**CITY OF DULUTH**  
Planning Division

**STAFF REPORT**

<b>File Number</b>	PL 14-061	<b>Contact</b>	Steven Robertson, 218 730 5295	
<b>Application Type</b>	MU-W Planning Review, Hotel	<b>Planning Commission Date</b>	June 10, 2014	
<b>Deadline for Action</b>	<b>Application Date</b>	May 30, 2014	<b>60 Days</b>	July 29, 2014
	<b>Date Extension Letter Mailed</b>	May 30, 2014	<b>120 Days</b>	September 27, 2014
<b>Location of Subject</b>	800 West Railroad Street			
<b>Applicant</b>	Pier B Holdings	<b>Contact</b>		
<b>Agent</b>	AMI Consulting Engineers	<b>Contact</b>	chad.scott@amiengineers.com	
<b>Legal Description</b>	010-3610-08075			
<b>Site Visit Date</b>	May 26, 2014	<b>Sign Notice Date</b>	May 27, 2014	
<b>Neighbor Letter Date</b>	May 22, 2014	<b>Number of Letters Sent</b>	2

**City Planning**  
 PL 14-061  
 Planning Review  
 Pier B

LANDSCAPE PLAN - CONCEPT A  
NOT TO SCALE

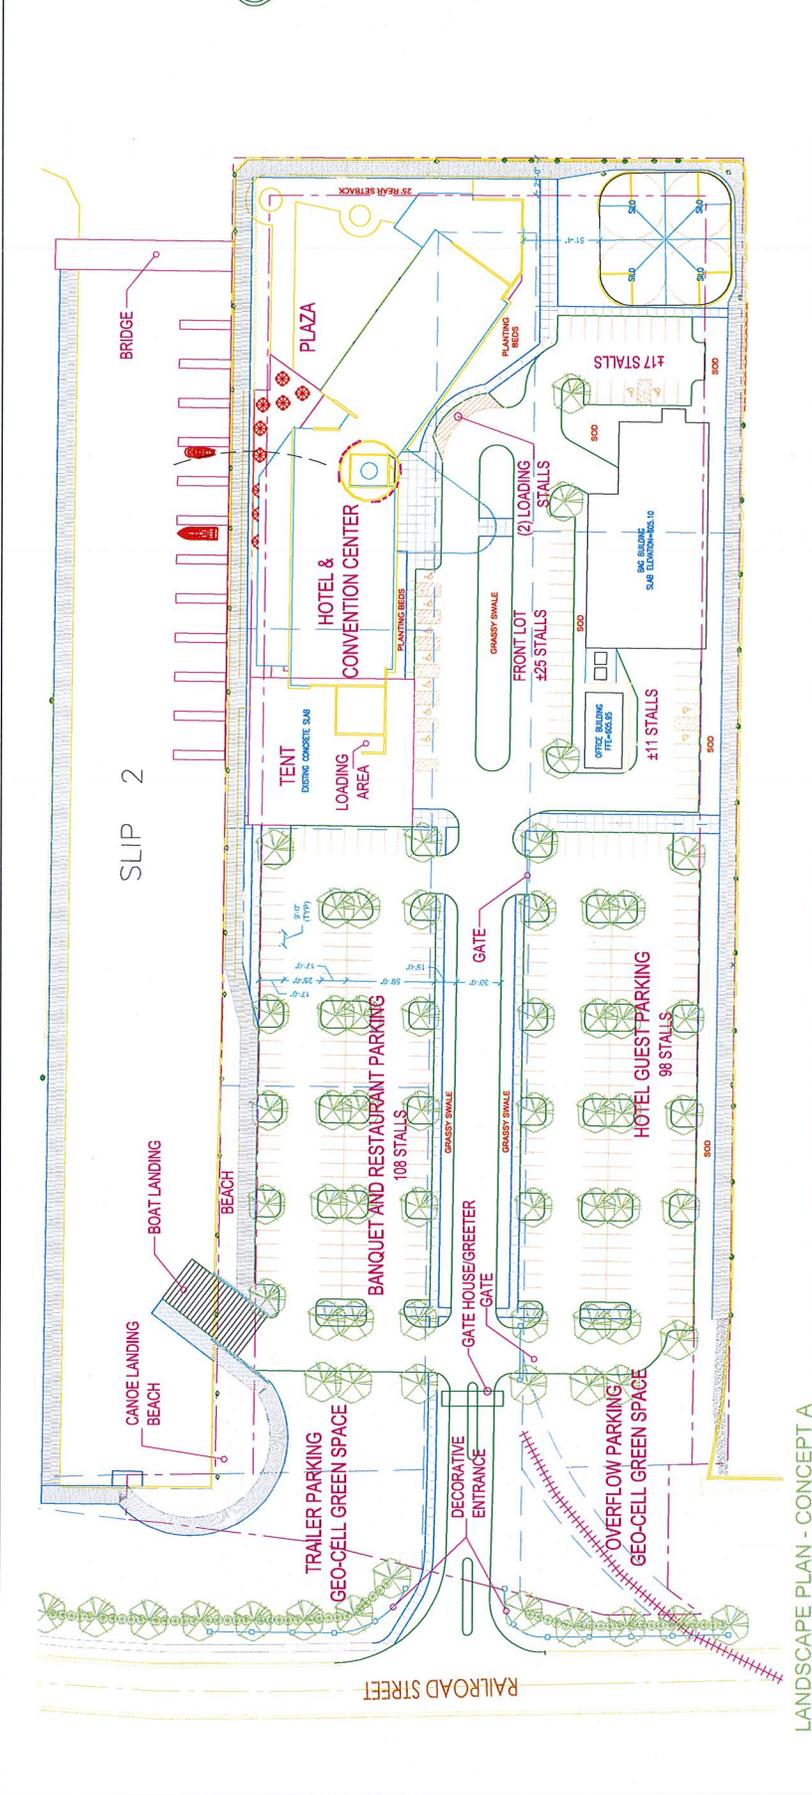
- 6) 50-25 (Landscaping and Tree Preservation). The applicant is required to provide 1 tree per 300 feet of interior landscaping (50 required, 51 provided). The applicant is aware of the 15% interior parking lot area landscaping and 30% tree canopy coverage requirement, but at this time it is not clear that the requirement is being met. The applicant will need to meet the standard, or receive an "Alternative Landscaping Plan" from the Land Use Supervisor for equivalent quality landscaping, prior to issuance of a building permit. The applicant is proposing geo-cell surfacing on two lots adjacent to the Railroad Street right of way; that does not meet the interior parking lot landscaping requirement. In addition, trailer parking is appropriate for this type of use (with an accessory marina/boat landing), but staff are not recommending approval of the overflow parking lot at this time. For the area designated "Overflow Parking", it has not been indicated the number of parking spaces or type of parking (or duration of parking).

- 2) The applicant revise the site plan to show compliance with the maximum parking requirement.
  - 3) The applicant revise landscaping plan to show compliance with landscaping requirements, or receive an approved Alternative Landscaping Plan from the Land Use Supervisor.

COMMUNITY-PANEL NUMBER  
270421 0040 D

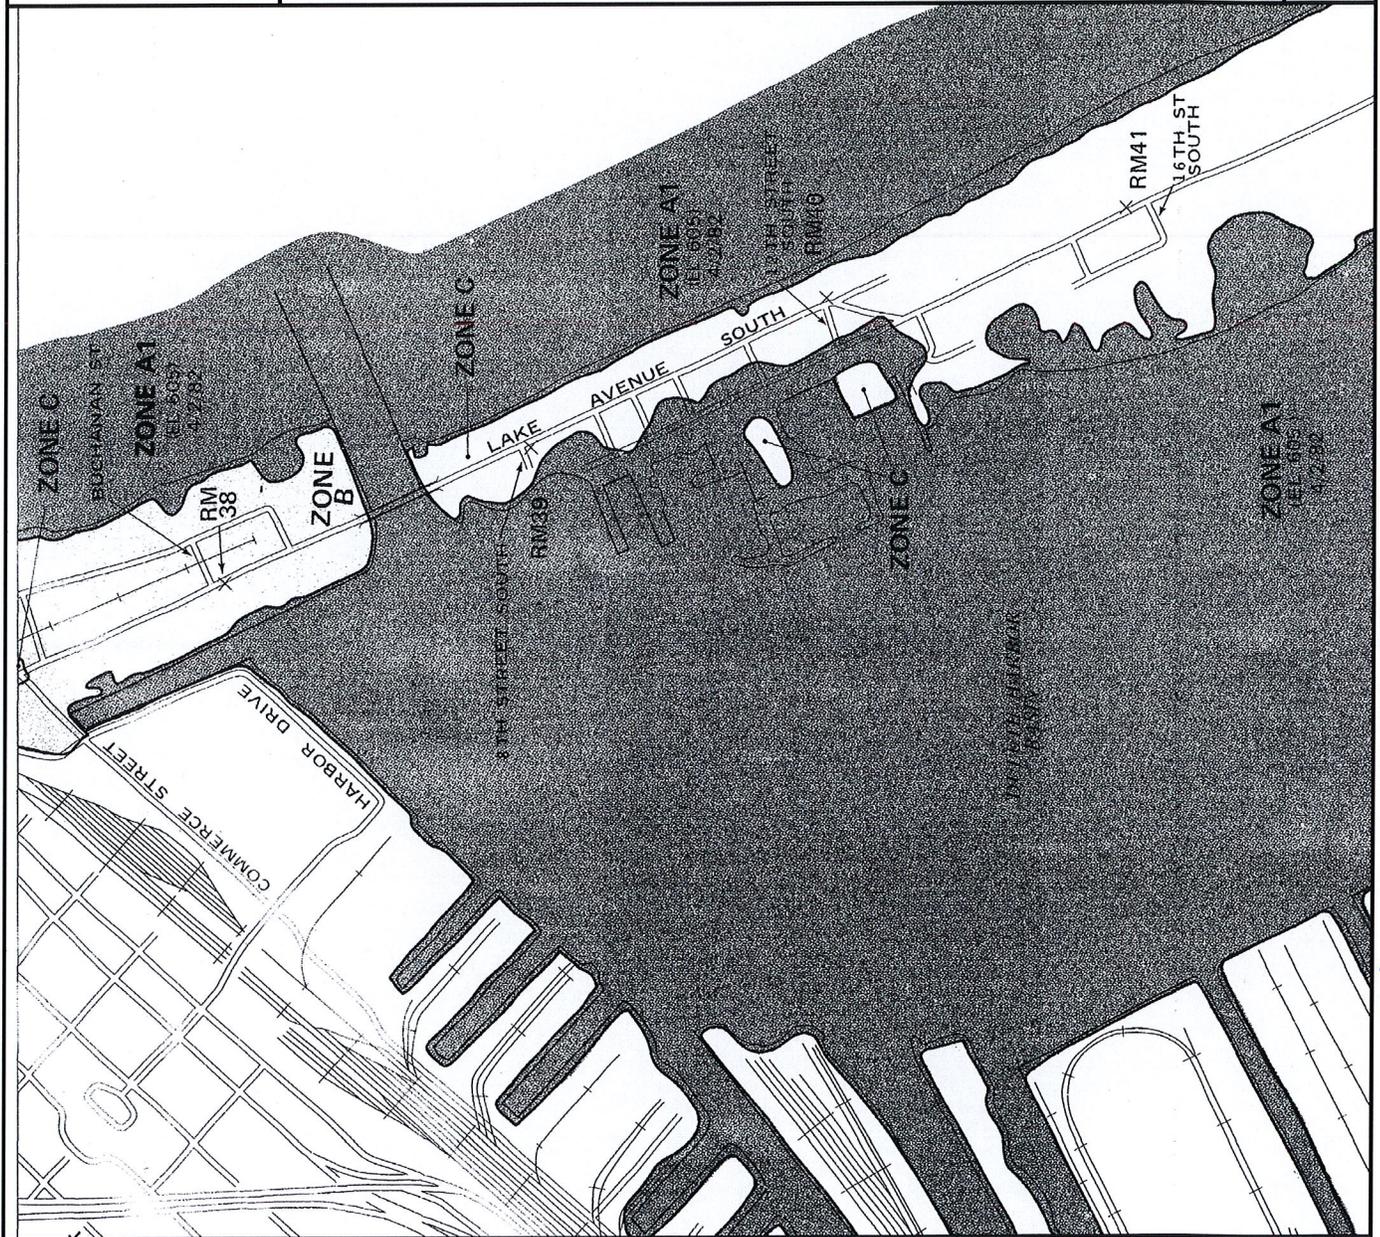
- 3) 50-18.1 Property is within the Harbor Shoreland Area (which allows reduced setbacks). It is not within a floodplain. FIRM panel 270421 0040D list the Base Flood Elevation of the harbor at 605; the Flood Protection Elevation is 607.
